## MICROLIGHT AIRWORTHINESS APPROVAL NOTE

MAAN NO: 2000

TITLE: Microlight Airworthiness Approval Note 2000,  
Skyranger – Service Bulletins 2000/1, 2000/2 and 2000/3.

Applicability: SB2000/1 – UK Skyranger aircraft with CKT exhaust (Rotax 912 and 912S variants)  
SB2000/2 – All UK Skyranger aircraft  
SB2000/3 – UK Skyranger aircraft with Kiev propellers

**Figure 1: CKT exhaust tailpipe highlighting the two welded seams prone to cracking**

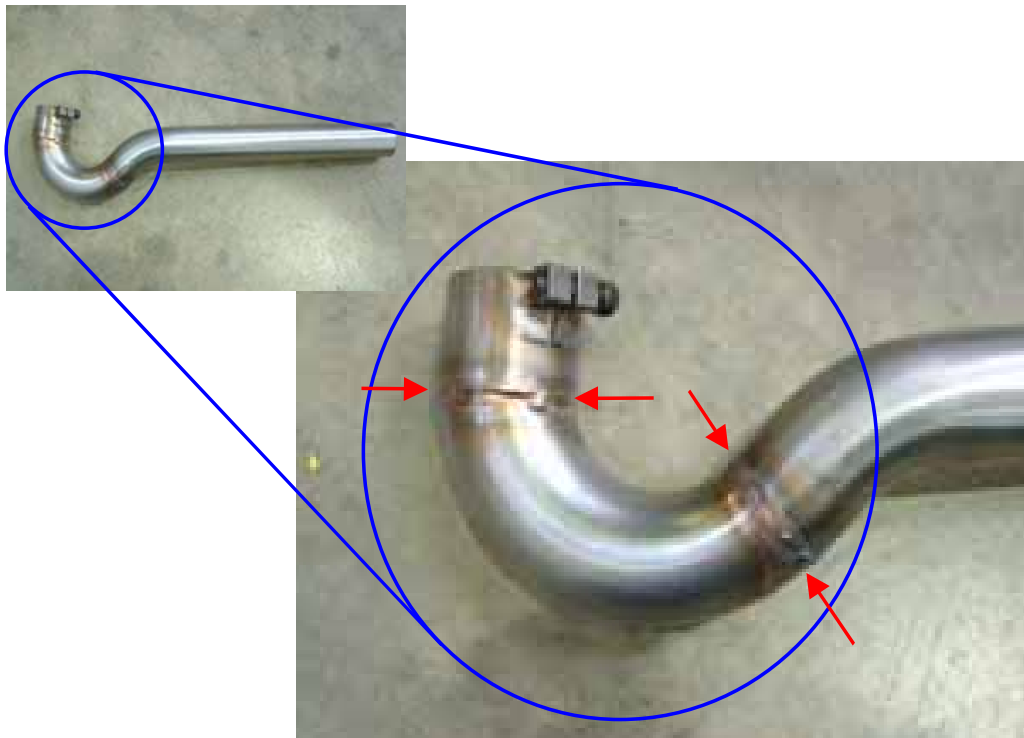
Instances of cracking of the tailpipe on CKT exhausts have occurred on Rotax 912S Skyranger variants. This problem has been reported on some examples after less than 100 hours. No such failures have been reported on 80hp Rotax 912 variants to date. The cracking may be due to start-up shake, which is noticeably more fierce with the Rotax 912S than with the 912.

The cracking occurs around two welded seams on the tailpipe downstream of the exhaust box on CKT exhausts – see appendix A for more details. The exhaust manufacturer has developed a corrective modification in the form of a ‘steady bracket’.

The welds on the exhaust tailpipe highlighted in figure 1 must be carefully inspected for cracks. A bright torch should be used to illuminate the welds. Cracks of any length require remedial action to be taken.

1. Before further flight carefully inspect the tailpipe for cracking. If any cracking is evident do not fly the aircraft, remove the exhaust and return it to CKT for remedial action and modification. If there is no cracking an entry must be made in both the airframe and engine logbooks stating that "***The initial inspection part of BMAA Service Bulletin 2000/1 (inspection and modification of CKT exhaust) has been carried out***", along with the name, qualification and signature of the person implementing the service bulletin. Note that it may be necessary to remove the lower cowling to perform a thorough inspection.

3. Within the next 10 hours, or before the next permit renewal if sooner, remove the exhaust and return it to CKT for modification. On its return, re-install the exhaust. An independent inspection of the re-installed exhaust, by an inspector or another pilot, is required before further flight.
4. An entry must be made in both the airframe and engine logbooks stating that *“BMAA Service Bulletin 2000/1 (inspection and modification of CKT exhaust) has been carried out”*, along with the name, qualification and signature of the person implementing the service bulletin.

This area can typically be satisfactorily inspected with removal of the top engine cowling only, because the underside of the welds can either be viewed from below the aircraft through the gap at the rear of the lower cowling, or from above using a mirror. However some installations may benefit from removal of the lower cowling in order to perform a thorough inspection of the problem area.

**Figure 1: Affected Kiev propeller spacer highlighting the 8mm clearance holes and the 12mm lightening holes**

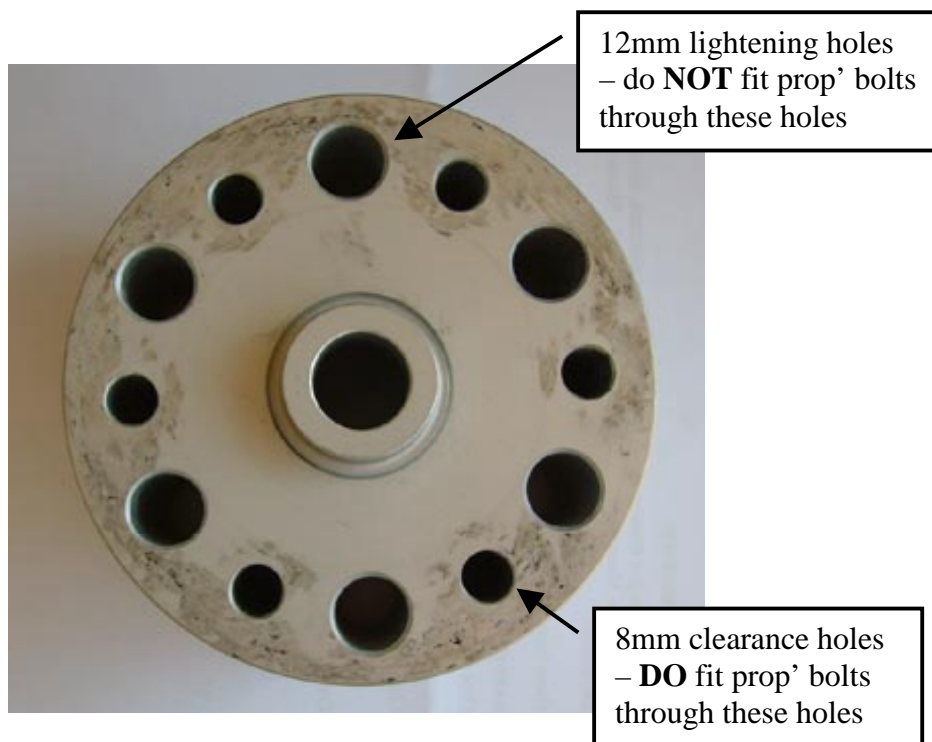
Some Kiev propeller spacers contain large diameter lightening holes in addition to the clearance holes for the propeller bolts – see appendix A for more details. It is possible to incorrectly install the propeller spacer with the propeller bolts through the lightening holes instead of the clearance holes. This puts bending loads through the propeller bolts (rather than pure shear loads), which cause premature failure of the bolts.

1. Before further flight remove the propeller and check that the propeller bolts have been correctly installed through the clearance holes in the propeller spacer, not through any larger diameter lightening holes.

2. If the propeller was incorrectly installed check for any damage to the propeller flange (on the prop' shaft emanating from the engine/gearbox), spacer and propeller hub. If any damage is found contact the BMAA for advice.

3. Re-install the propeller using the instructions supplied with the propeller: these should be at annex G to the operator's manual, or a copy can be obtained from Flylight Airsports Ltd. In particular ensure that the correct torques are used and that the propeller bolts are safety wired in place to avoid them loosening in service. If the propeller was incorrectly installed new propeller bolts **must** be used and the old bolts disposed of. New bolts are available from Flylight Airsports Ltd.
